ITEM: 6.3	REPORT SUMMARY MINOR VARIANCE APPLICATION FILE NUMBER A109/24
------------------	--

MINOR VARIANCE APPLICATION FILE NUMBER A109/24

CITY WARD #:	2
APPLICANT:	Anthony Macri
AGENT:	Lucas Cocomello
PROPERTY:	162 Davidson Drive, Woodbridge
ZONING DESIGNATION:	See below.
VAUGHAN OFFICIAL PLAN (2010) DESIGNATION:	Vaughan Official Plan 2010 ('VOP 2010'): "Low-Rise Residential" by Volume 2, Section 11.11 – Woodbridge Centre Secondary Plan.
RELATED DEVELOPMENT APPLICATIONS:	None
PURPOSE OF APPLICATION:	Relief from the Zoning By-law is being requested to permit a proposed addition (attached garage) to the existing dwelling and an existing covered patio, gazebo and pool equipment shed.

○ SITE PLAN - COVERAGE

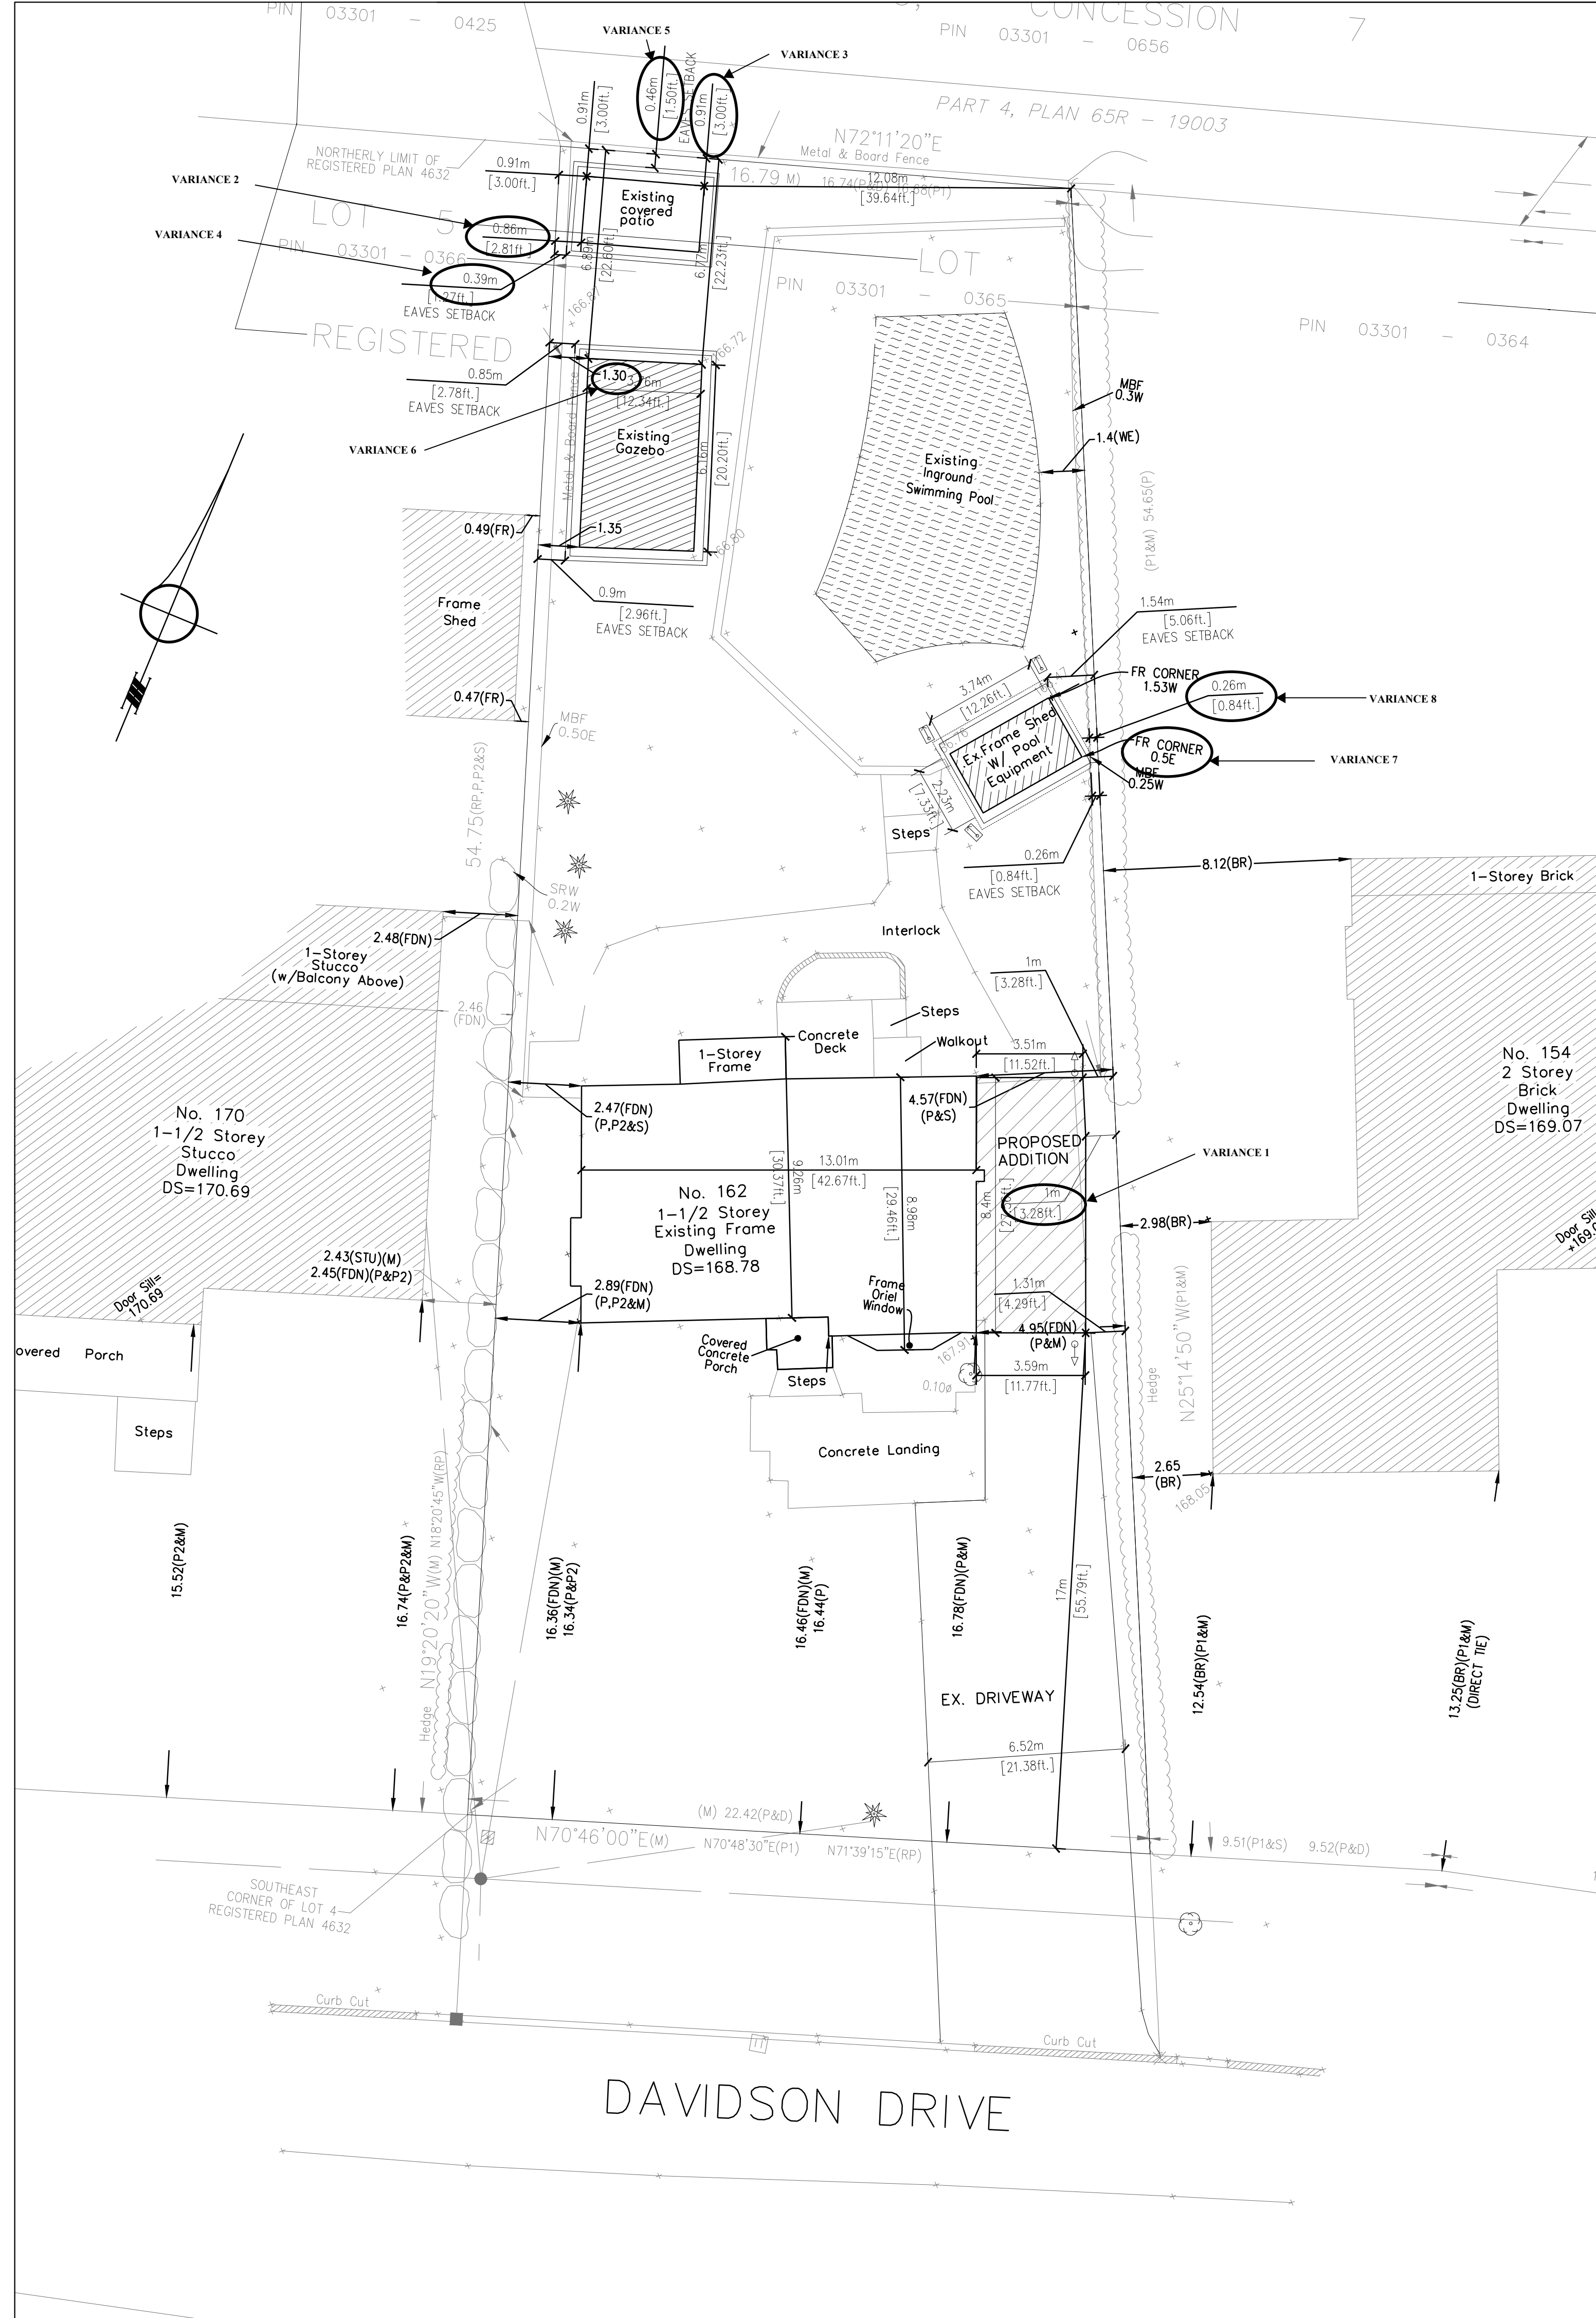
The Owner is seeking relief to permit an easterly single-car garage addition to the existing dwelling, as well as to recognize three (3) separate residential accessory structures in the rear yard: a shed (labeled on the site plan as 'covered patio'), a cabana (labeled on the site plan as 'gazebo'), and a pool equipment storage shed, with the above-noted variances.

The Development Planning Department has no objection to Variance 1 for the proposed reduced minimum interior side yard to accommodate a one-storey addition to the east of the existing dwelling. The proposed flat-roof single-storey garage addition, at 3.38 m tall, is modest in height in relation to the existing pitched roof 1.5 storey dwelling, the highest point of which is approximately 6.15 m tall. The proposed addition, which would accommodate a single vehicle, is in-line with the abutting north and south walls of the existing dwelling. The driveway currently extends up into the east interior side yard and is used to part a vehicle. The garage will further formalize the vehicle parking on this portion

of the property. Unlike most other properties on Davidson Drive, 162 Davidson Drive does not currently have a garage. The addition will create a garage feature in keeping with nearly all lots along Davidson Drive. An existing Eastern White Cedar hedgerow located on the neighbouring property to the east (154 Davidson Drive) provides an adequate buffer between the two properties. Urban Design staff anticipates that the construction of the proposed addition will impact the existing hedgerow, and recommends that a consent letter from said neighbour be obtained as a condition of approval. The 1.0 m reduced setback maintains sufficient space for exterior access between the front and rear yards. Overall, the proposed 30.15 m² addition is modest in footprint and mass, is appropriately screened from the directly abutting property (152 Davidson Drive), and still provides for a functional interior side yard. The addition maintains the intent of the side yard setback provision and is desirable for the development of the land.

The Development Planning Department has no objection to Variances 2, 3, 4, and 5 for the proposed interior and rear setback reductions and increased encroachments to the shed located in the northwestern corner of the rear yard. The existing shed is walled on all sides and has a floor area of 8.49 m². The reduced minimum setbacks of 0.86 m and 0.91 m from the west interior side and rear lot lines respectively maintains sufficient space for access and maintenance. Due in large part to its modest footprint, the shed is also modest in mass. The shed has a hip roof design, which further mitigates mass. As the shed is walled on all four sides, does not contain any windows, and is located near wood privacy fences, the reduced setbacks are not anticipated to incur adverse use (privacy) or massing impacts on the abutting neighbours to the west (170 Davidson Drive) and the north (20 Lloyd Street). The parts of the eaves which project furthest towards the rear lot line and west interior side lot line are located approximately 2.27 m above ground, and are not anticipated to impede access to the rear and west interior side yards. Development Engineering staff have reviewed the shed and do not anticipate that the eave projections will incur additional stormwater drainage issues on the neighbouring properties to the west (170 Davidson Drive) and the north (20 Lloyd Street).

The Development Planning Department has no objection to Variance 6 for the proposed 1.30 m minimum setback from the cabana to the west lot line. The cabana is located in the western portion of the rear yard and south of the existing shed. The cabana has a hip roof design with a top of roof height of 3.63 m and a mean roof height of approximately 2.95 m. The cabana is fully walled on the north and west sides, and opens to the dwelling and the pool on the south and east sides. Overall, the cabana is modest in mass, and complies with maximum height and coverage provisions. The 1.30 m setback provides adequate spatial separation from the west lot line to allow for access and maintenance. As such, the cabana is not anticipated to incur adverse use (privacy) or massing impacts on the abutting neighbour to the west (170 Davidson Drive).

The Development Planning Department has no objection to Variances 7 and 8 for the proposed setback reduction and increased eave encroachment from the eastern lot line to the pool equipment storage shed located in the southeastern corner of the rear yard. The pool equipment storage shed is oriented to frame the irregularly shaped inground pool, and projects towards the east lot line at an angle. The 0.5 m interior side yard setback and 0.26 m eave projection setback are therefore only required at the southeastern corner of the shed, which is a pinch point, increasing to approximately 1.50 m and 1.55 m respectively. The shed is 2.69 m in height from the established grade, but is built into a small slope. Therefore, the height of the shed from ground level is only approximately 1.87 m at its southeastern extremity. The mass it presents towards the abutting easterly neighbour (154 Davidson Drive) is modest. An Eastern White Cedar hedgerow also exists on the neighbouring property to the east and provides adequate visual buffering to mitigate any anticipated adverse massing impacts. Development Engineering staff have reviewed the pool equipment shed and do not anticipate any adverse drainage issues to be incurred by the proposed eaves of the shed.

1. That the applicant provides a consent letter signed by the residents of 154 Davidson Drive acknowledging the potential impact on the hedge trees within proximity to the proposed garage addition, to the satisfaction of the Development Planning Department.
